ORIGINATION FORM

Proposed Revisions to a Standard Plans Index
(Please provide all information — Incomplete forms will be returned)

Index Number: 455-154

Index Title: 60" Prestressed CFRP & SS Concrete Cylinder
Pile

ELEVATION

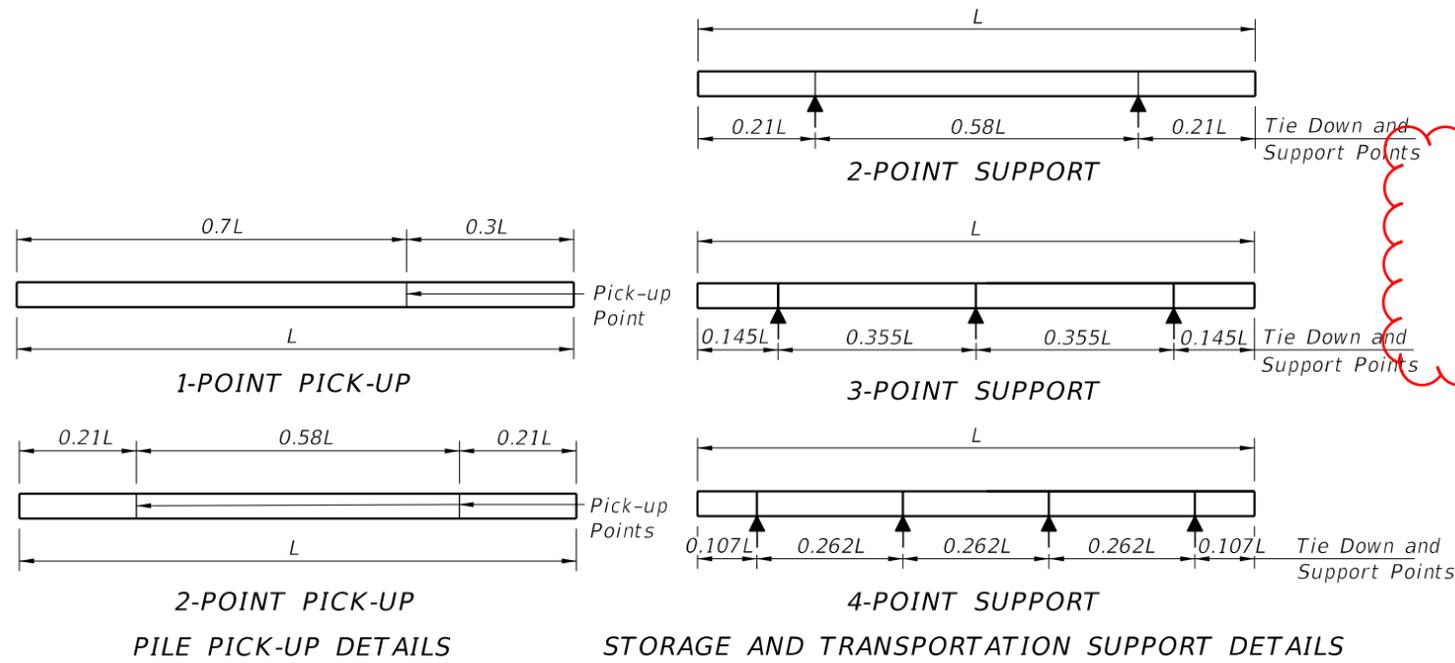
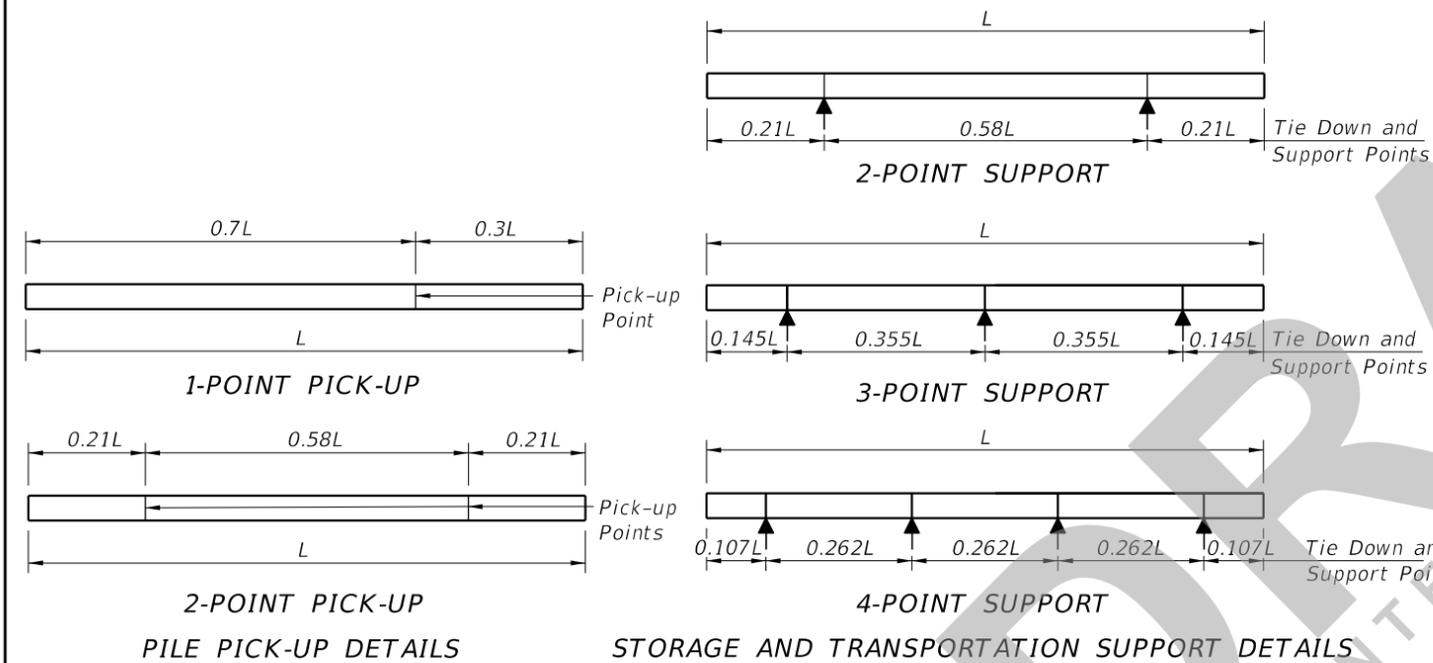
Change Silica Fume, metakaolin or ultra-fine flyash to Highly Reactive Pozzolans

Specification changed to fit silica fume, metakaolin and ultra-fine flyash under Highly Reactive Pozzolans

- Work this Index with the Pile Data Table in the Structures Plans.
- Concrete:
 - Piles: Class V (Special)
 - Splice Collar: Class IV
 - ~~Silica Fume: See "GENERAL NOTES" in the Structures Plans for locations where the use of silica fume, metakaolin or ultra-fine flyash is required.~~

Highly Reactive Pozzolans

- Work this Index with the Pile Data Table in the Structures Plans.
- Concrete:
 - Piles: Class V (Special)
 - Splice Collar: Class IV
 - See "GENERAL NOTES" in the Structures Plans for locations where the use of Highly Reactive Pozzolans is required.
